Michael Collins Architect LLP

6 Chaomans Letchworth

Job No. 188 Plans as Proposed

Stage: Stage 3
Status: Non-material amendment

012

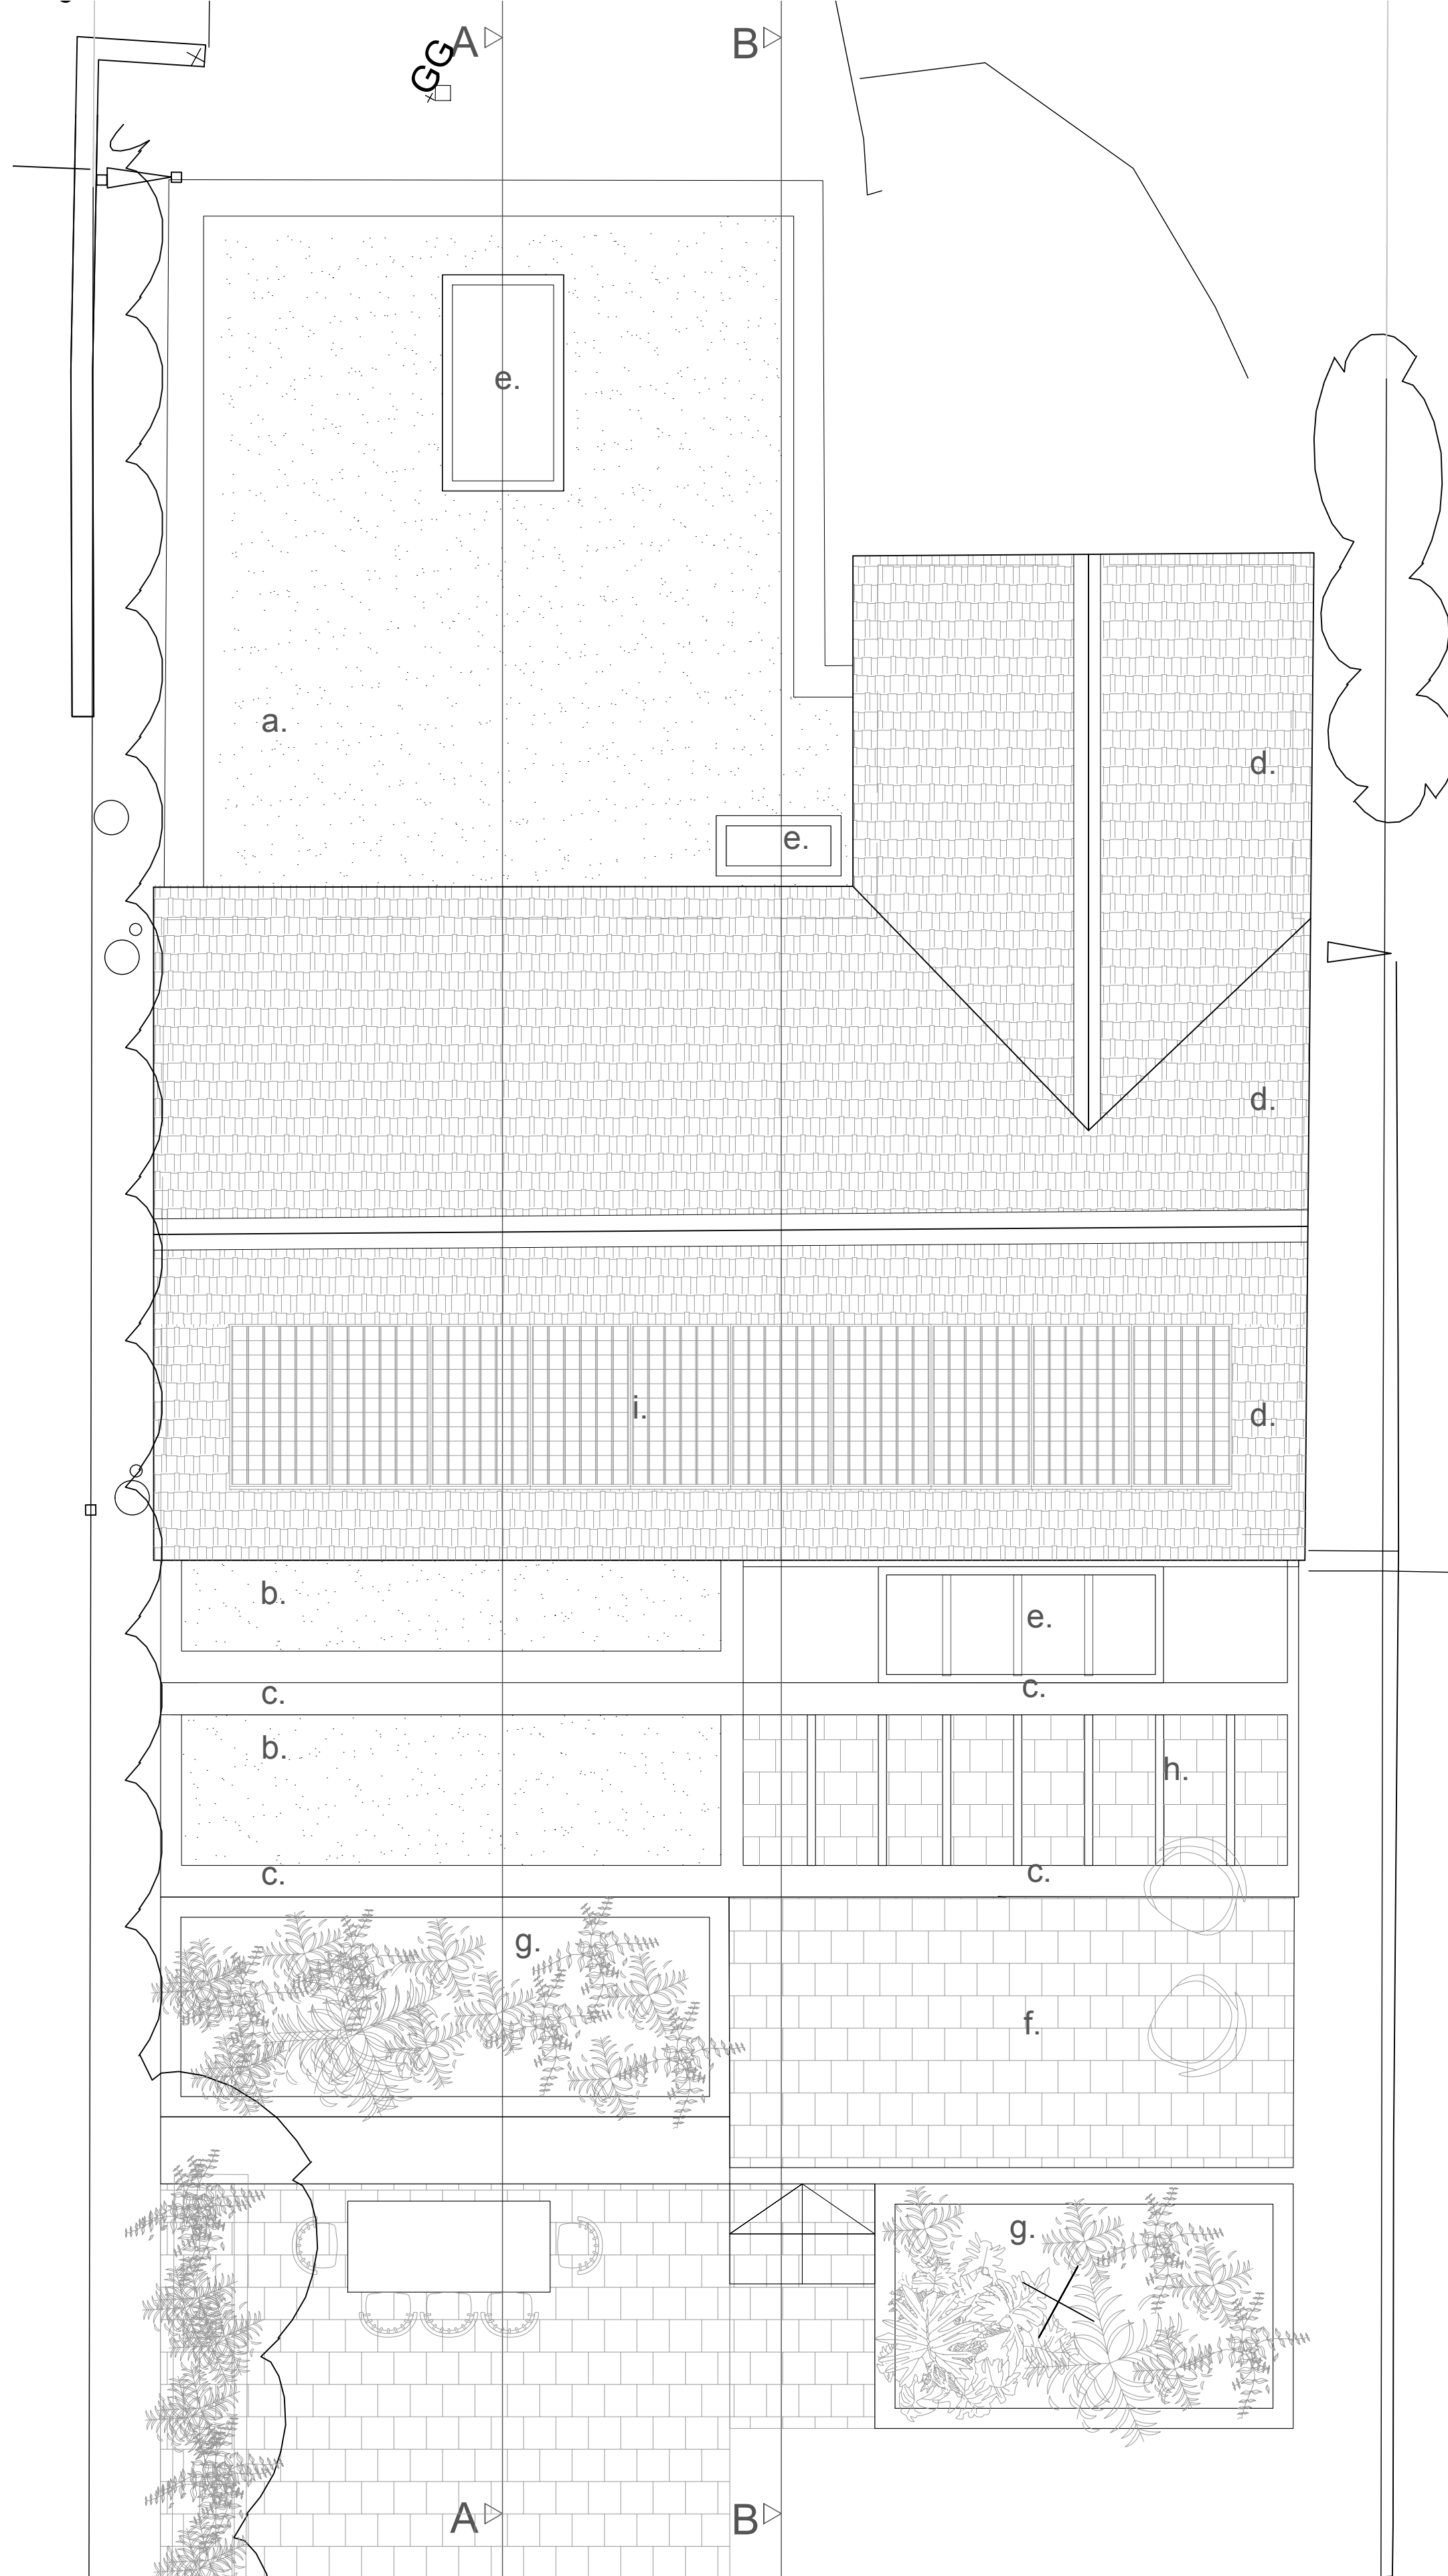
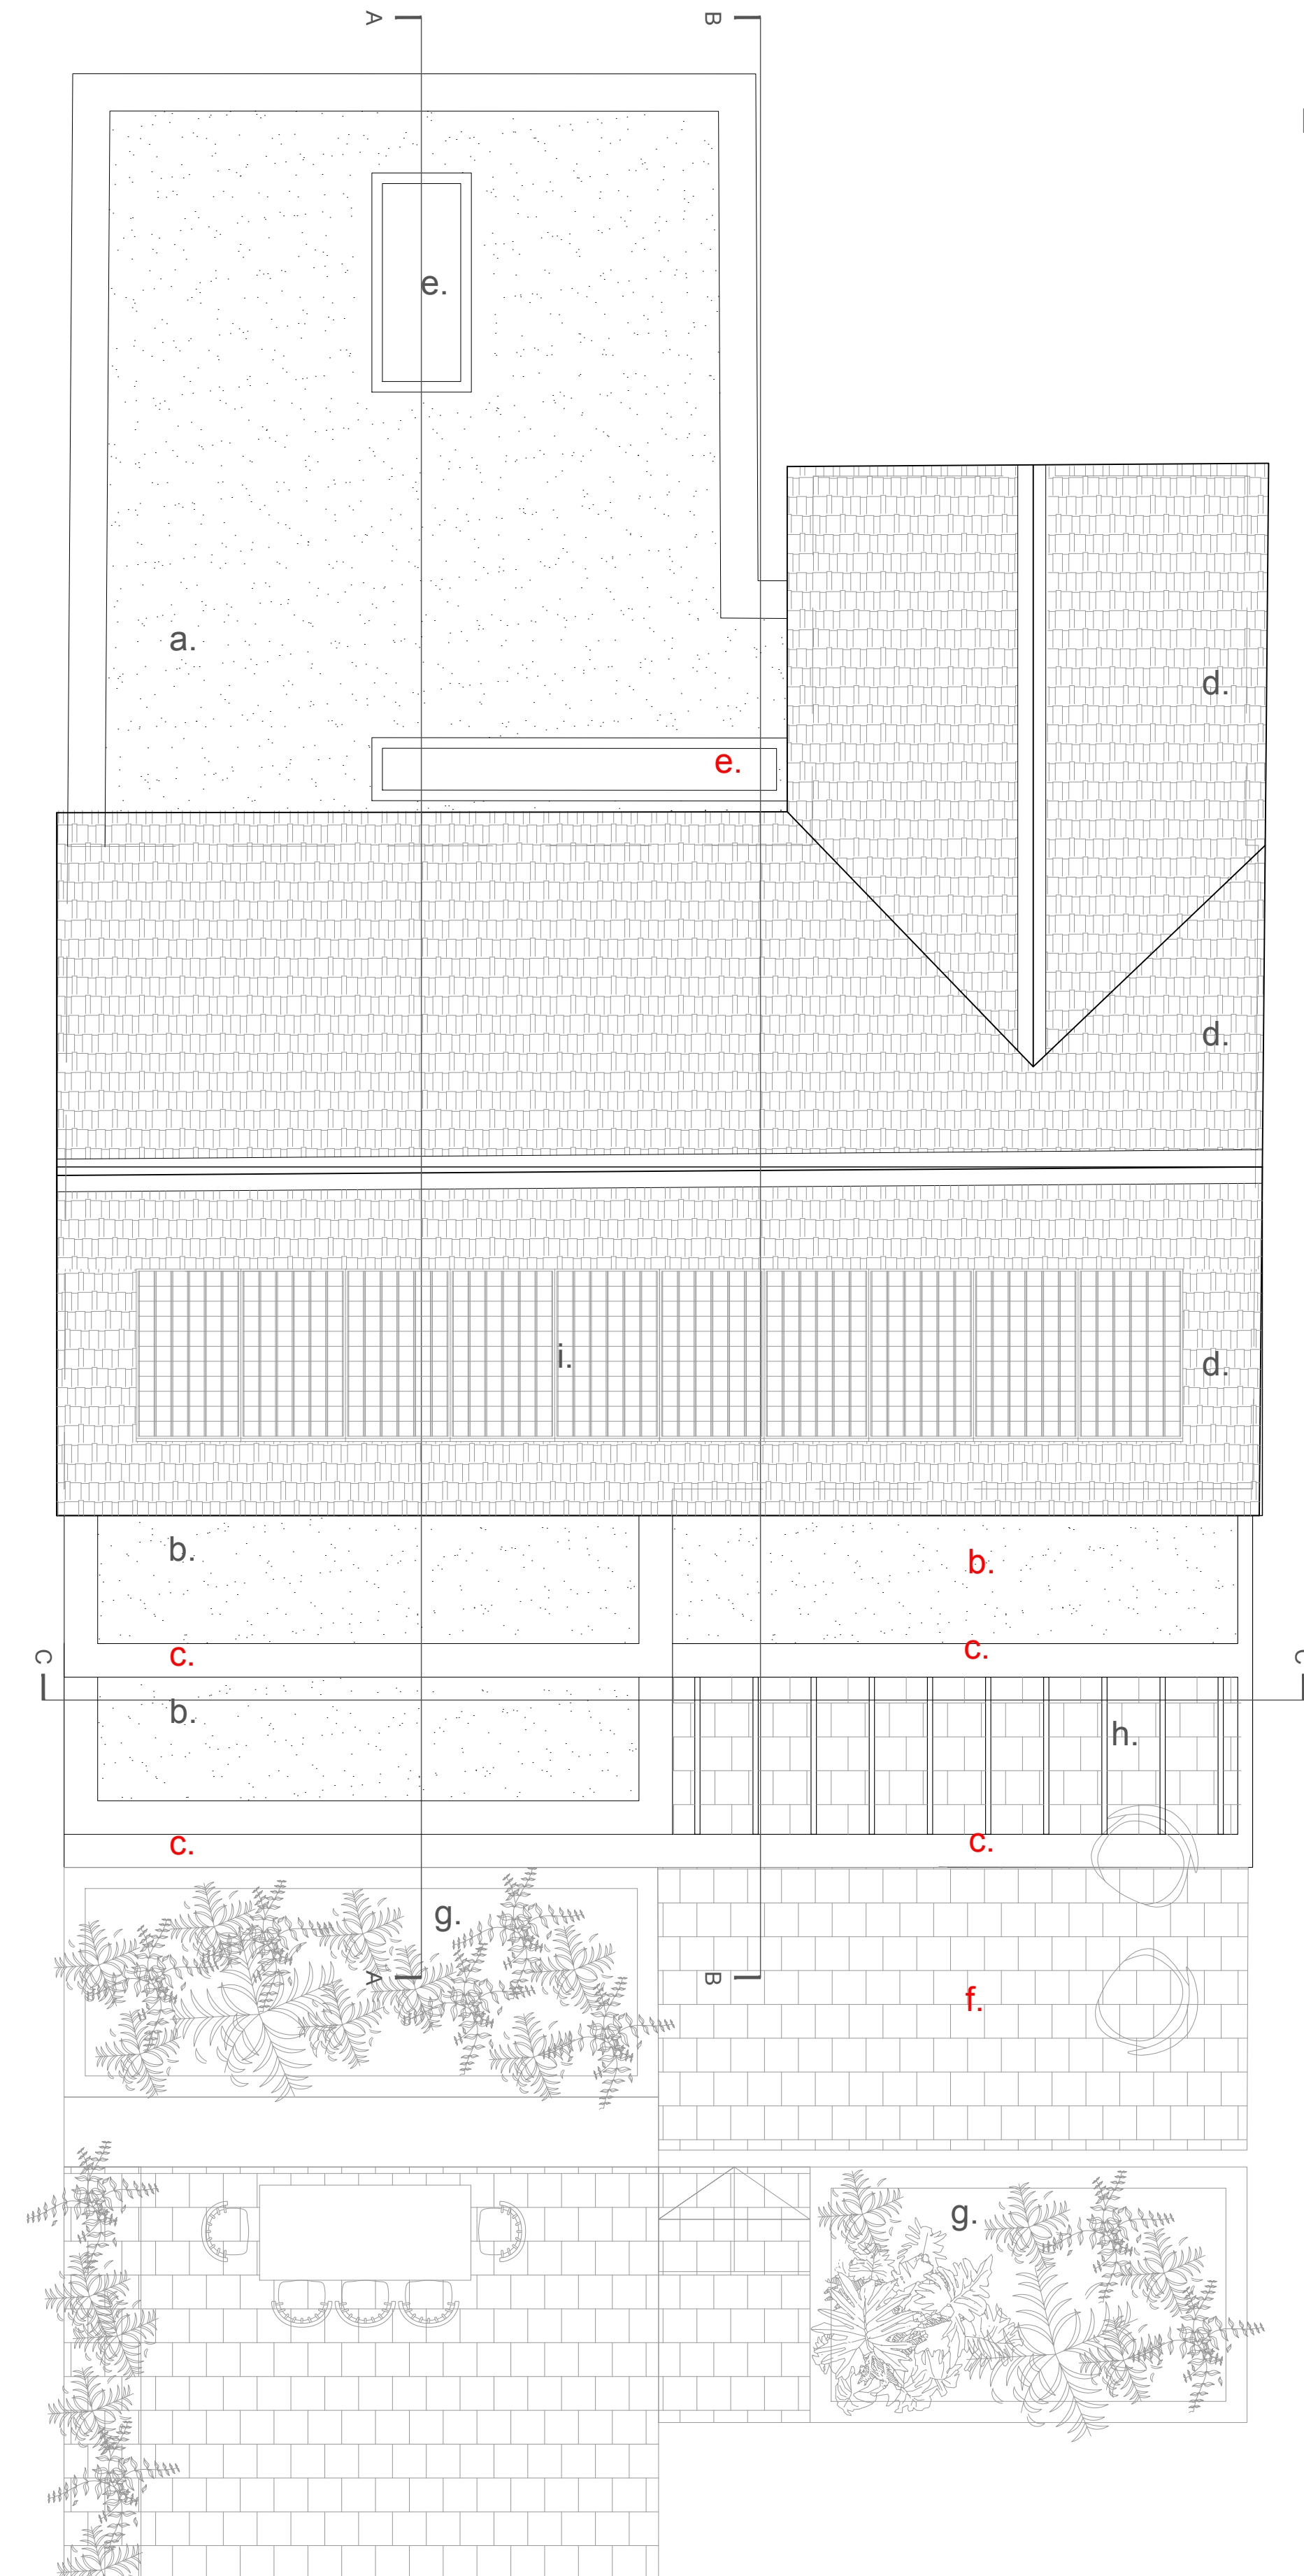
- a. Wildflower flat roof
- b. New green flat roof
- c. New aluminium RAL 7013 cladding frame
- d. Existing tiles
- e. Roof light
- f. Brick terrace or timber decking terrace
- g. Raise bed
- h. Pergola
- i. Placement for new solar panel
